Statement

Product Name: LTE Module

Model Number: FM101-CG

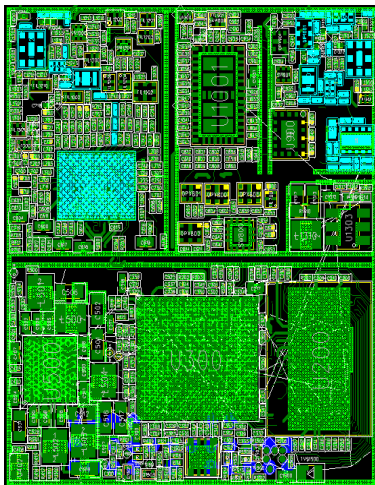
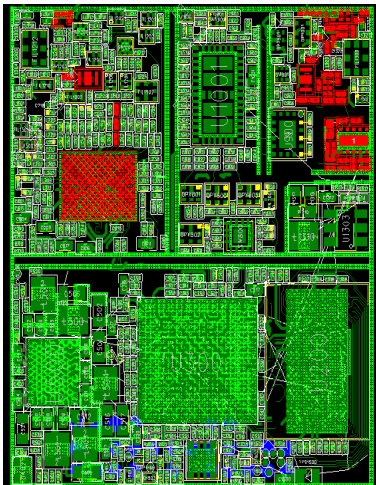
FM101-NA and FM101-CG use identical internal printed circuit board layouts, have a common design and components, and where the separate FCC IDs differ only in the depopulation of components for the purposes of removing frequency bands of operation.

FCC ID	ZMOFM101NA	ZMOFM101CG
HWID	HWID 2/1/0: HHH	HWID 2/1/0: HHH
List 4G LTE categories and technology supported	FDD/TDD, DL: CAT6, UL:CAT6	TDD, DL: CAT6, UL:CAT6
List FDD/TDD LTE Frequency bands supported	LTE FDD: Band 2, 4, 5, 7, 12, 13, 14, 17, 25, 26, 29, 30, 66, 71 LTE TDD: Band 41, 42, 43, 46, 48	LTE TDD: Band 42, 43, 48
WCDMA	Band 2,4,5	N/A
List 3GPP CA combinations supported (both DL and UL CA)	CAT6 supports: DL_2CA	CAT6 supports: DL_2CA
PCB Layout		
Confirm HPUE Support	YES	No

Antenna port	main/div/GNSS	main/div/GNSS
UL MIMO (2*2)	Not support UL CA	Not support UL CA
DL MIMO (2*2)	LTE FDD: Band 2, 4, 5, 7, 12, 13, 14, 17, 25, 26, 29, 30, 66, 71 LTE TDD: Band 41, 42, 43, 46, 48	LTE TDD: Band 42, 43, 48

Above changes won't impact the protocol and RF performance for same frequency bands.
Your assistance on this matter is highly appreciated.
